External Decking

1 Alder Rise, Whaley Bridge

Proposed Site Plan and sketch

1116.05

Proposed site plan

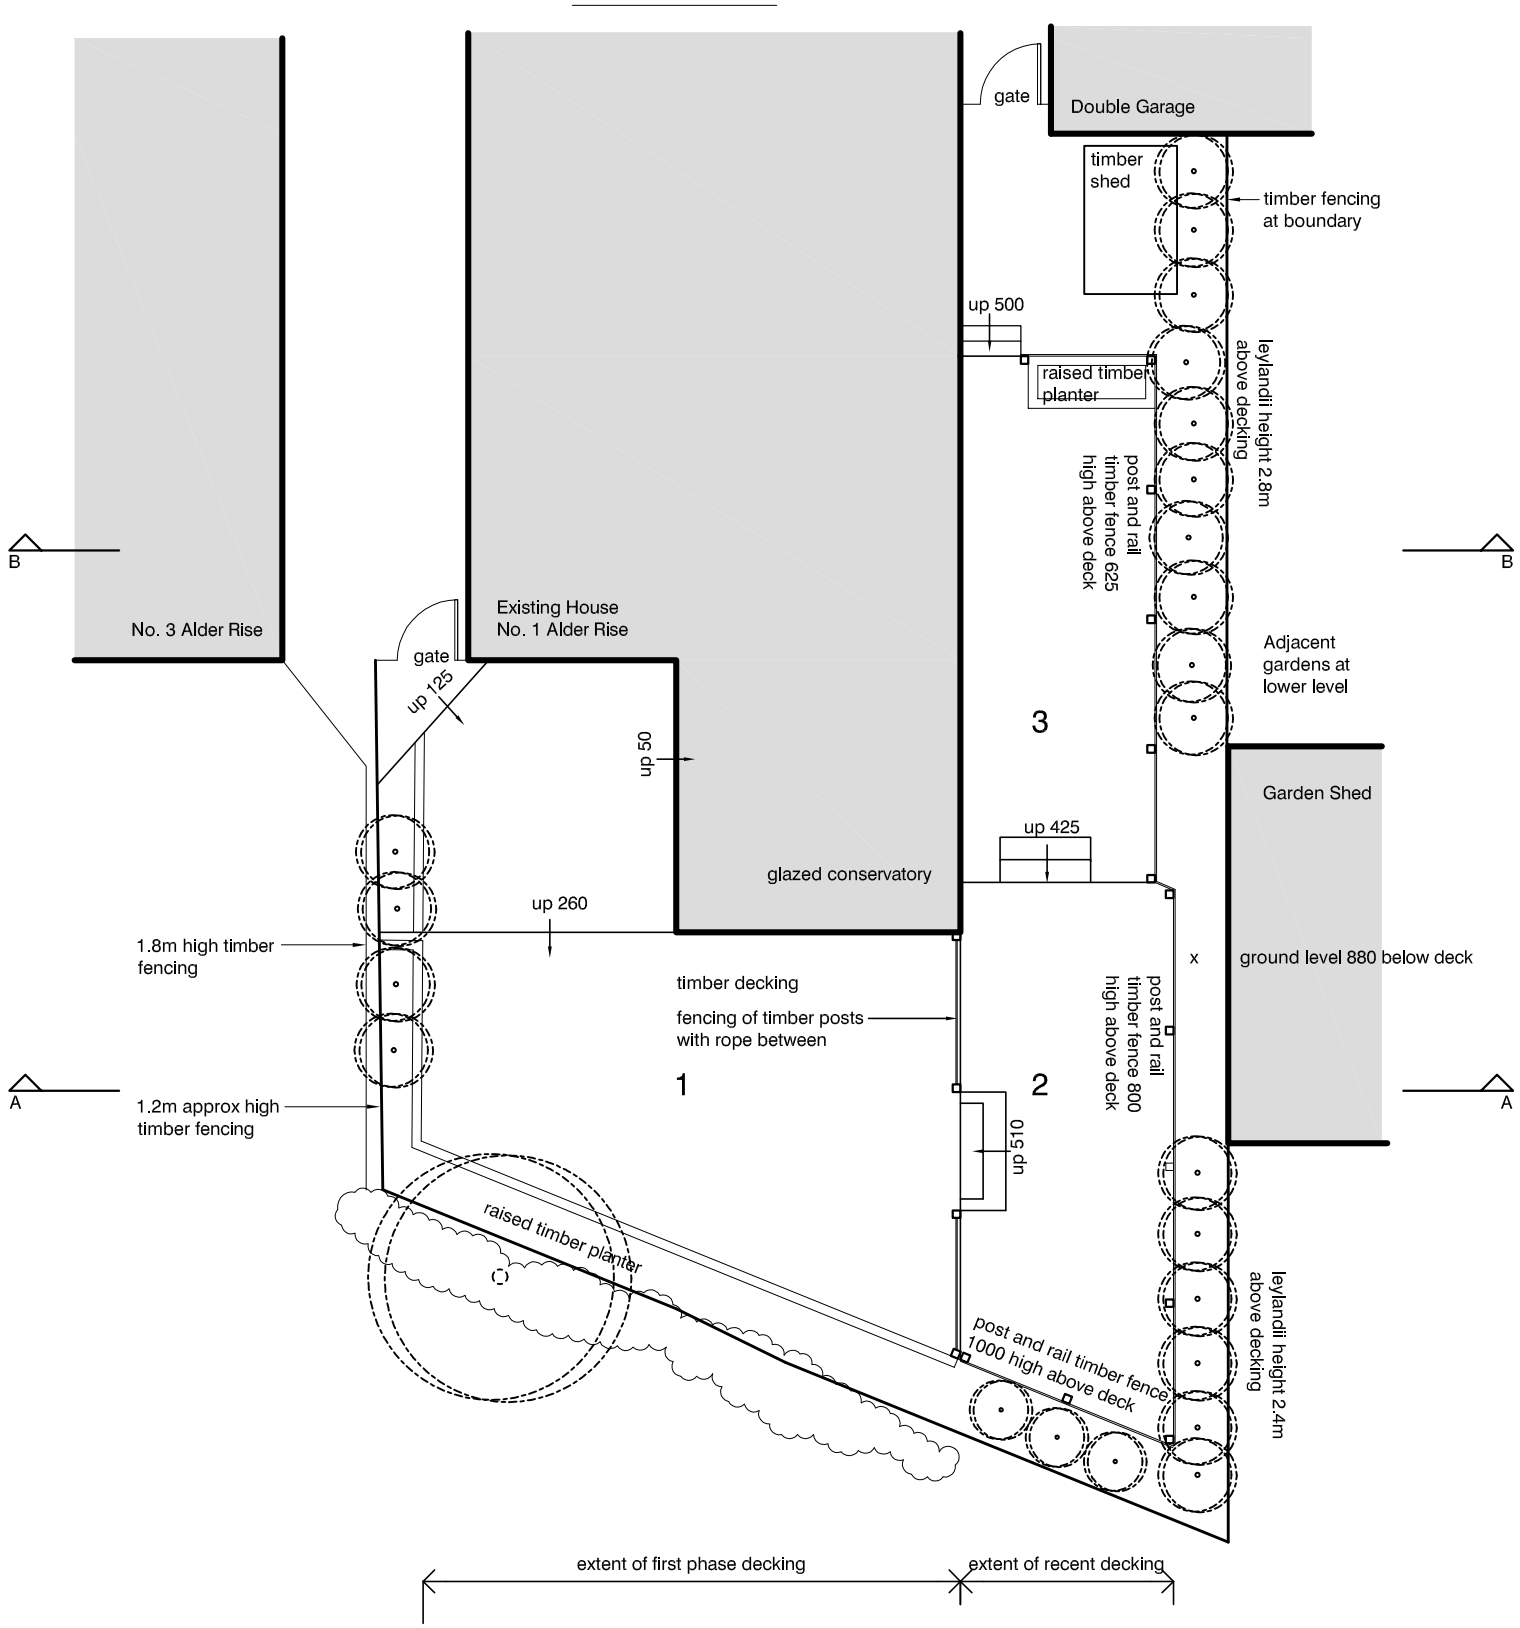
Revised proposal:
Sections of decking 3 and 4 reduced in height by 600mm below what is currently the level of section 3. This is the lowest it can be taken without removing earth from underneath.
Section 1 and 2 remain the same as the current condition as neither can be dropped any further.
The safety fencing is shown as current - however the client would be amenable to a close boarded fence to a height of 1.8m if required.

Indicitive drawing to give a guide where the decking is located adjacent to existing house

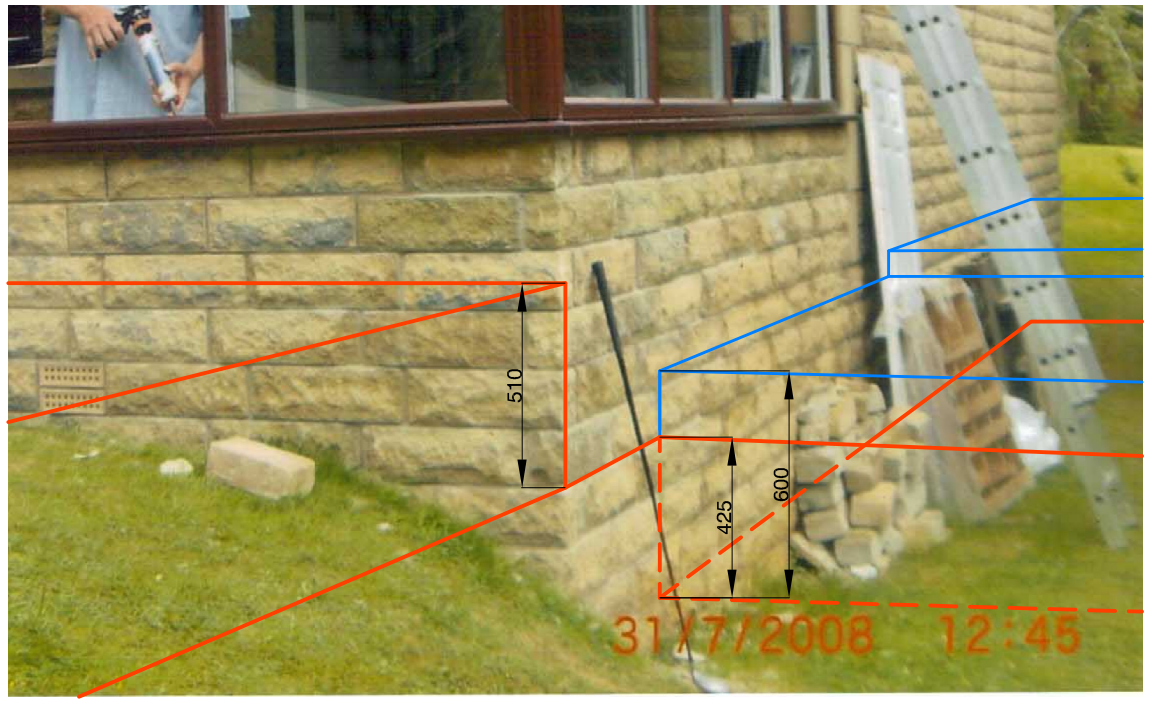
The red lines show the revised proposed decking location
The blue lines show the previous levels of decking areas 3 and 4
